**Addendum 1**  
**Solicitation 22-99400**  
**Lift Station 17 Generator and Control Panel**

This addendum serves to notify all bidders of the following changes to the solicitation documents:

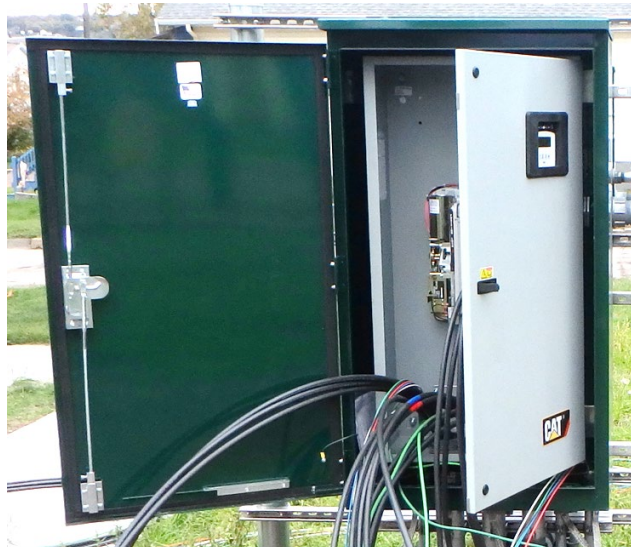
1. No gas utility is required.
2. The following new equipment provided under this contract shall be painted as specified:
  - a. Generator, sub-fuel tank, and enclosure
  - b. ATS exterior enclosure
  - c. Meter socket exterior enclosure
  - d. All junction boxes on the equipment rack
  - e. Main Disconnect Switch, MDS-1
  - f. Lighting Panel exterior enclosure

The follow photo is an example of equipment rack and equipment from previous project that meets the intent of the contract and City standards.
